BROWNS FERRY NUCLEAR PLANT (BFN) – UNITS 1, 2, AND 3 – TECHNICAL SPECIFICATIONS (TS) CHANGES TS-418 AND TS-431 – EXTENDED POWER UPRATE (EPU) – RESPONSE TO ROUND 23 REQUEST FOR ADDITIONAL INFORMATION (RAI) REGARDING STEAM DRYER SIGNAL PROCESSING (TAC NOS. MD5262, MD5263, AND MD5264)

**TENNESSEE VALLEY AUTHORITY
BROWNS FERRY NUCLEAR PLANT (BFN)
UNITS 1, 2, AND 3**

**TECHNICAL SPECIFICATIONS (TS) CHANGES TS-431 AND TS-418
EXTENDED POWER UPRATE (EPU)**

**RESPONSE TO ROUND 23 REQUEST FOR ADDITIONAL INFORMATION (RAI)
REGARDING STEAM DRYER SIGNAL PROCESSING**

Figure EMCB.203-1.22a: Cross spectra (top) and coherence (bottom) of CLTP data with LF subtracted and bias and uncertainty applied, for BFN1 main steam line A.

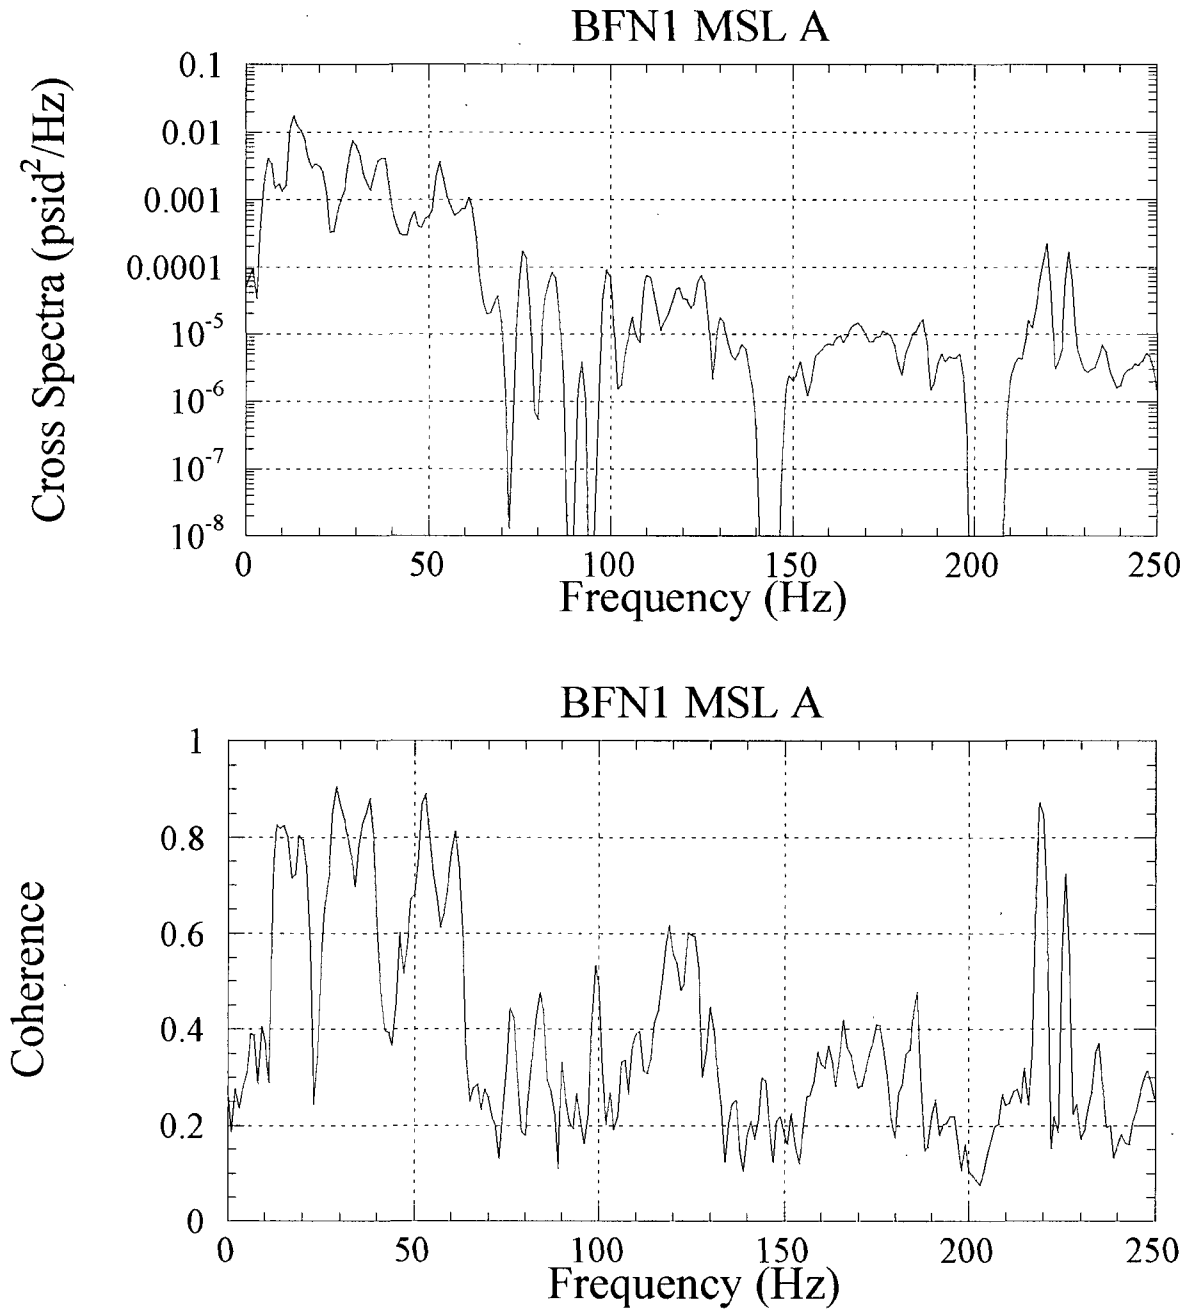
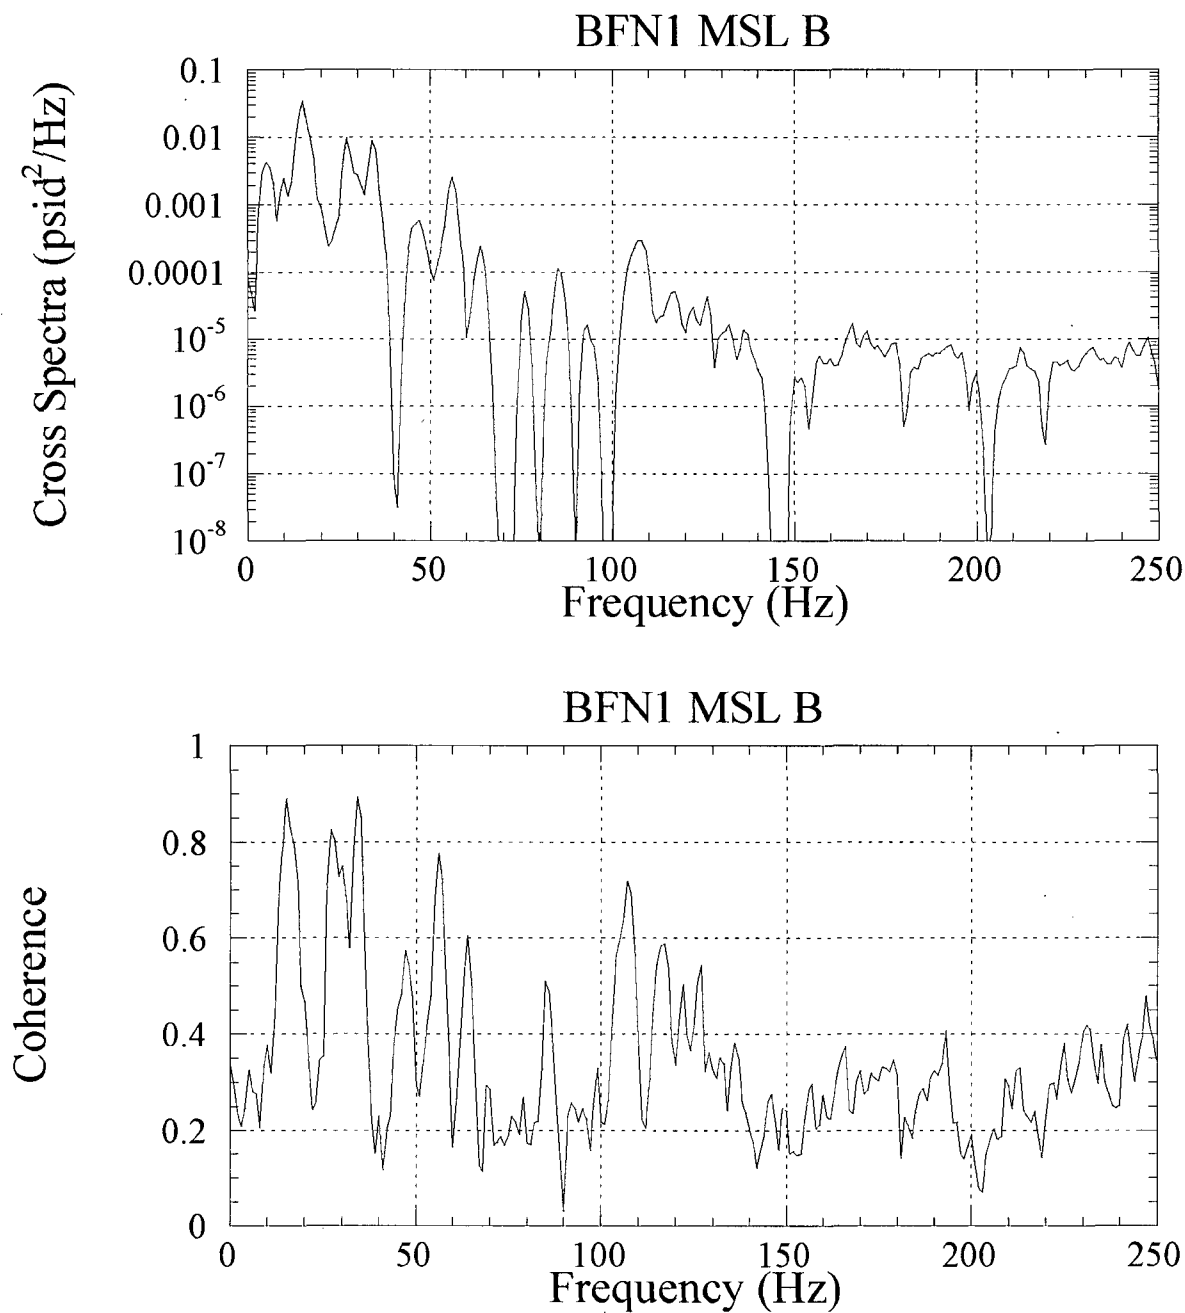
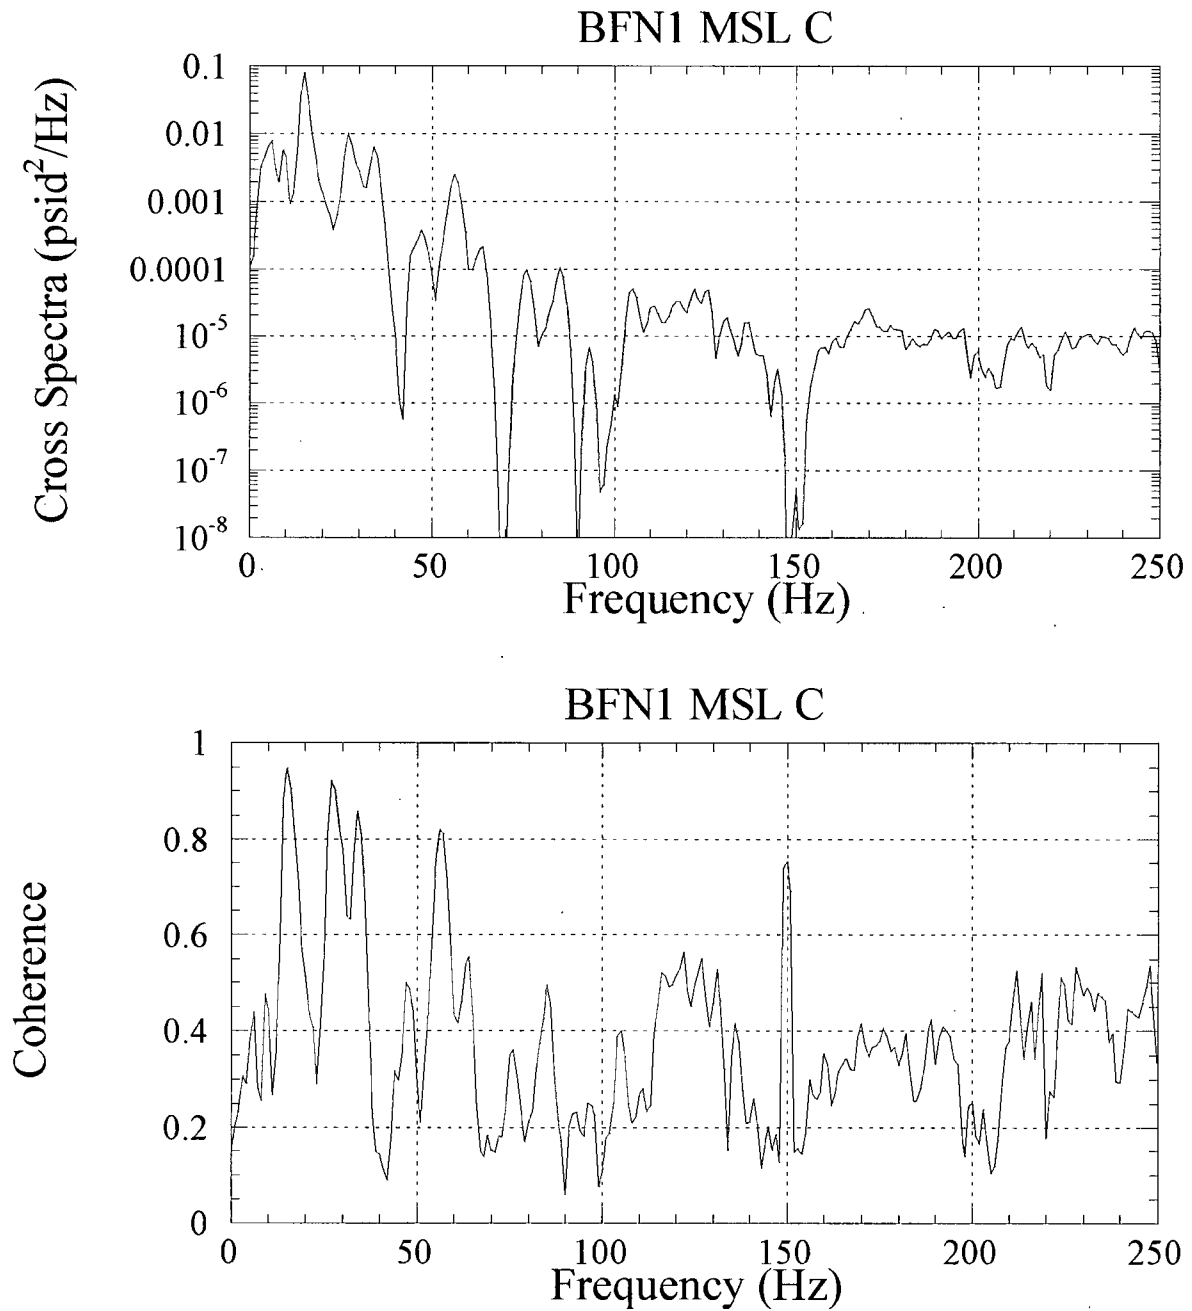
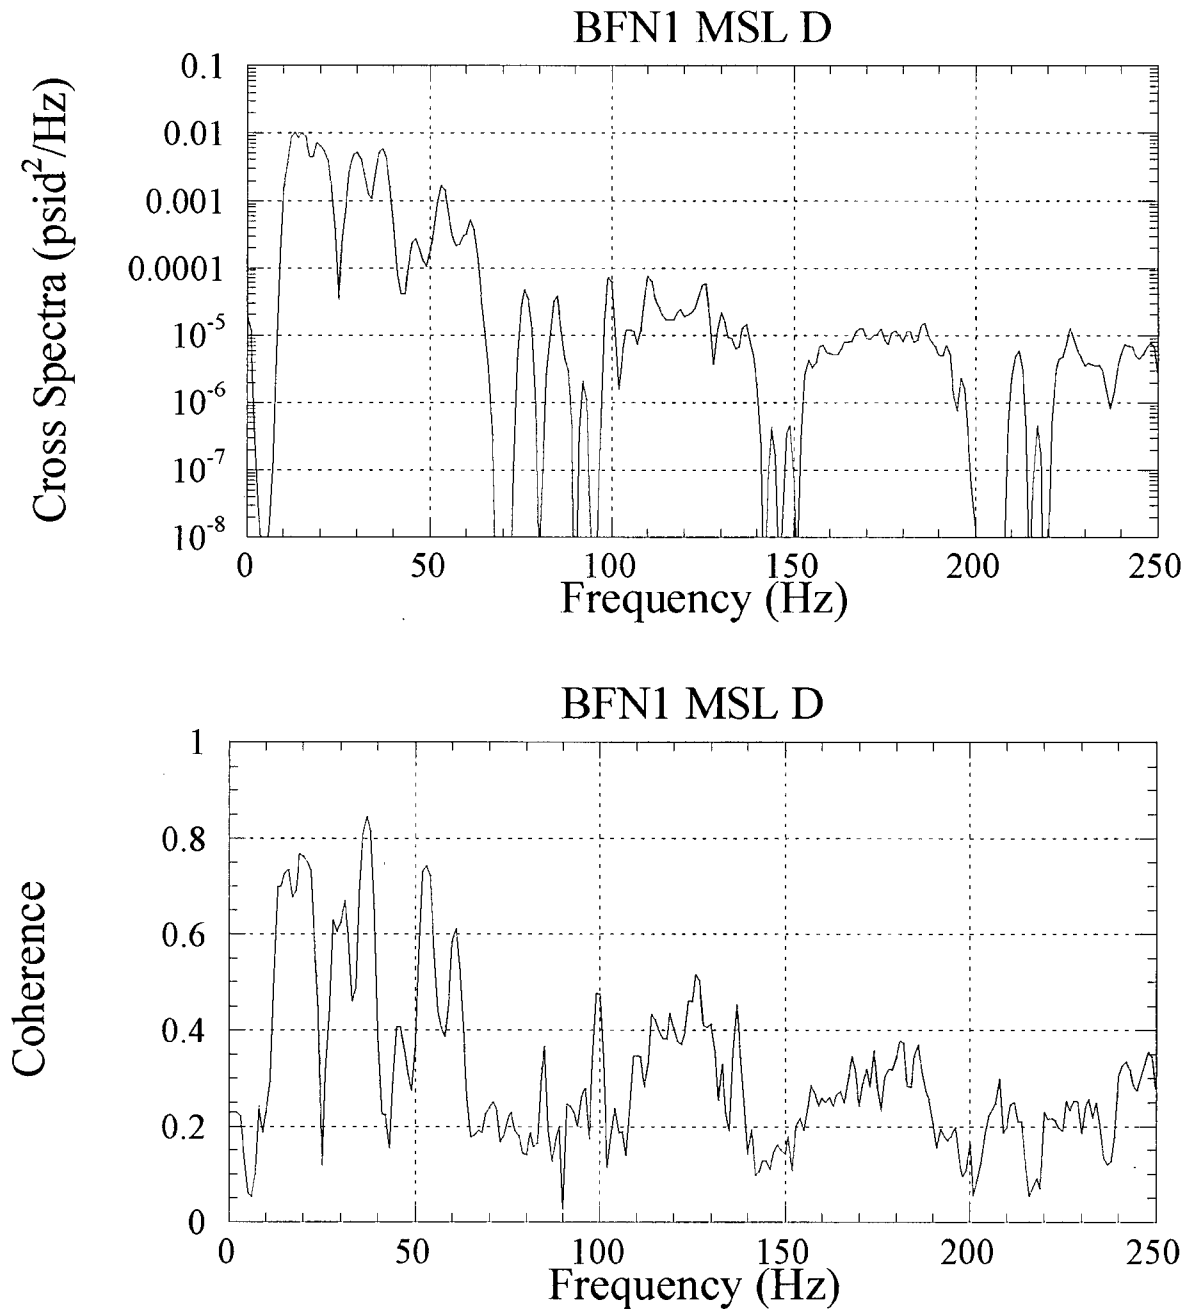
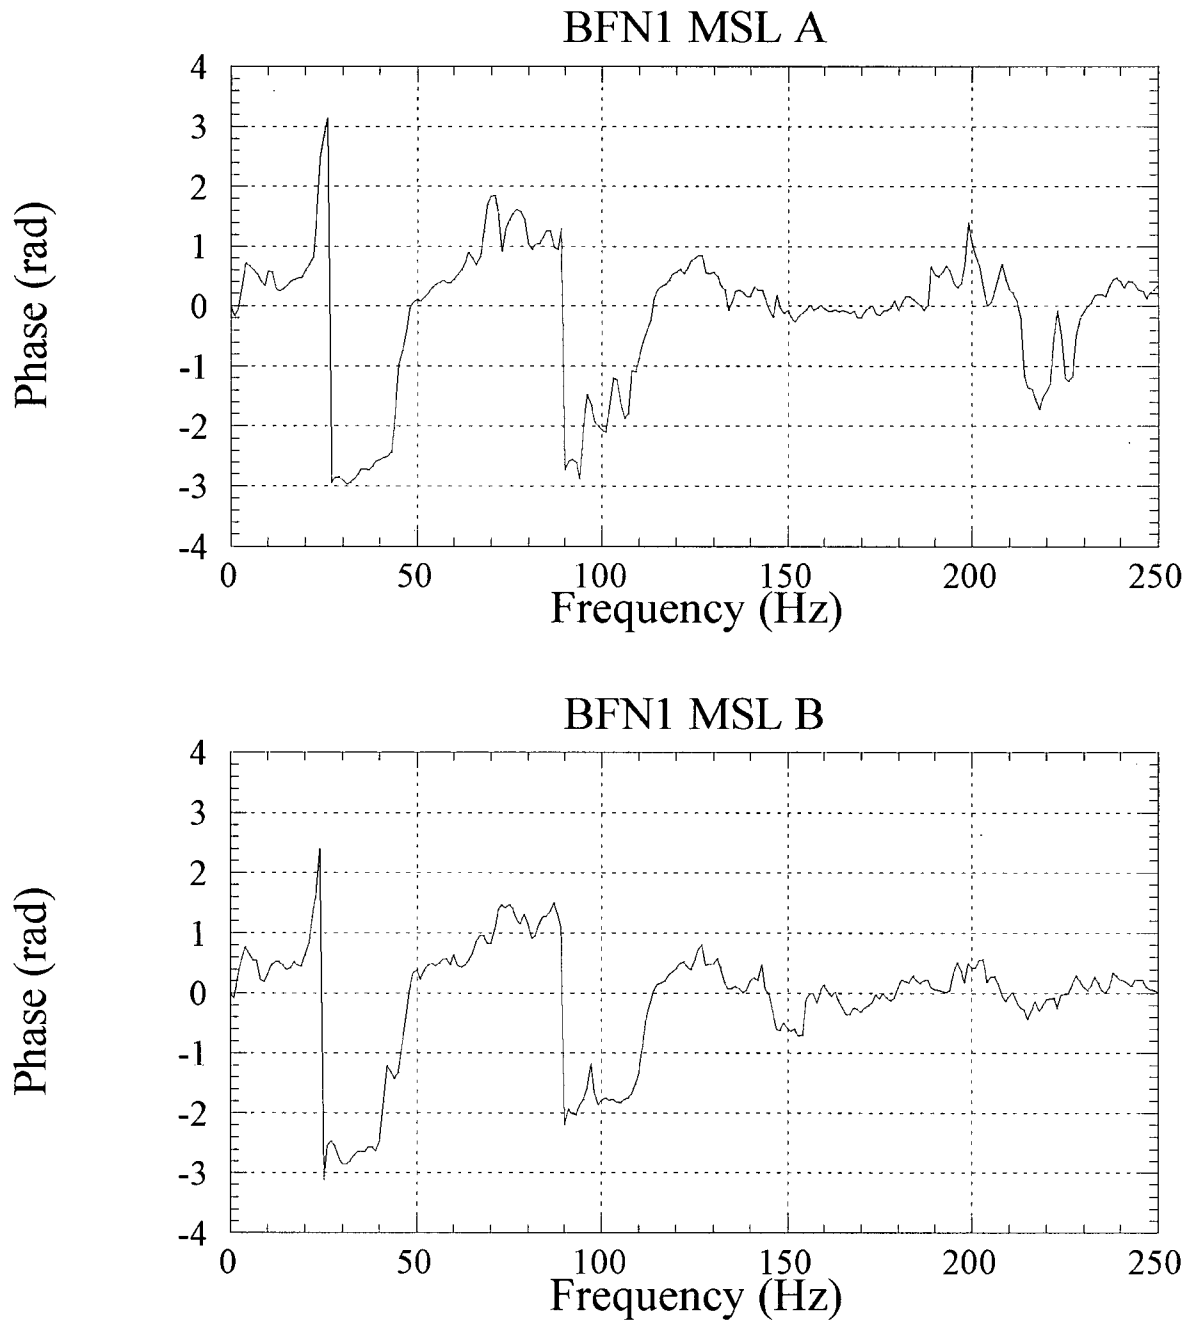
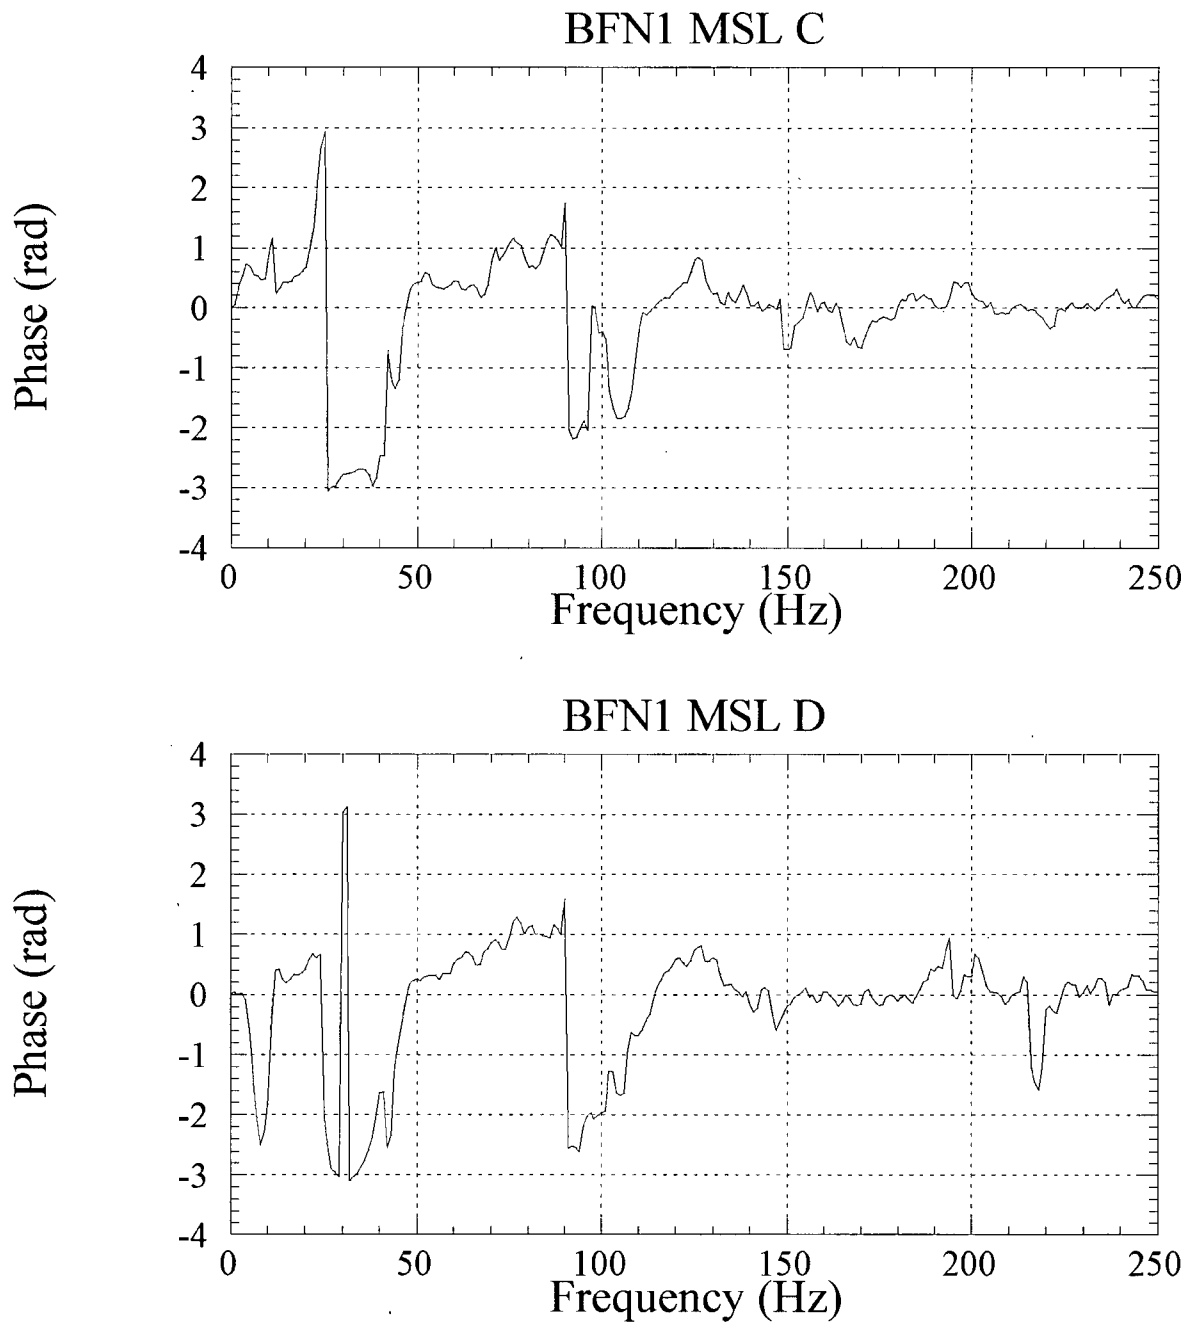
In response to EMCB.200/157., TVA presents detailed discussion of signal conditioning in six steps. Provide plots of strain gage signals (autospectra, cross spectra, coherence, and phase) and computed [[]] throughout the procedure described in their RAI response (prior to step 1, after step 1, after step 2, after step 4 and after step 6), for current license thermal power (CLTP) and Low Flow (LF) signals, for Units 1 and 2.

After Step 6: subtract low flow and apply bias and uncertainty
